Engineering Change Request		ECR Number	R7658W	
Initiator:		Holiday	Date:	2024.08.15
Part number description				
Item	K3 Code (Pls list all part numbers)	Drawing/Doc Number	Version of current related document	New Version
1	N/A	C-HVSL282062XX	N/A	N/A
2	N/A	C-HVSL282062XXXXX V2	N/A	N/A
3	N/A	C-HVSL282062XXXXM	N/A	N/A
4	N/A	C-HVSL282062XXXXU	N/A	N/A
5	N/A	C-HVSL282062XXXXX	N/A	N/A
6	N/A	C-HVSL282062XXXXX-ND	N/A	N/A
7	N/A	C-HVSL282062N1	N/A	N/A
8	N/A	C-HVSL282062A003IL1500	N/A	N/A
9	N/A	C-HVSL282062A104IL2000	N/A	N/A
10	N/A	C-HVSL282062A104IL5000H6W	N/A	N/A
11	N/A	C-HVSL282062X062XX XXILXXXX	N/A	N/A
12	N/A	C-HVSL282062X062XX XXIWLXXXX	N/A	N/A
13	N/A	C-HVSL282062XX03IJN	N/A	N/A
14	N/A	C-HVSL282062XX04ILXXXX	N/A	N/A
15	N/A	C-HVSL282062XX04ILXXXXH10	N/A	N/A

HVSL282 series CPA optimizes unlocking feel and adjusts the inclination of the unlocking surface.

Before change

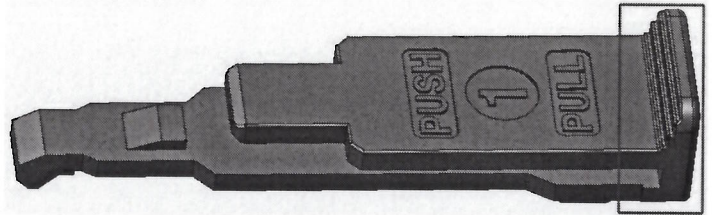
The finger contact surface inclination angle is 135°

The inclination angle of the finger contact surface is adjusted to 110° to improve the unlocking feel.
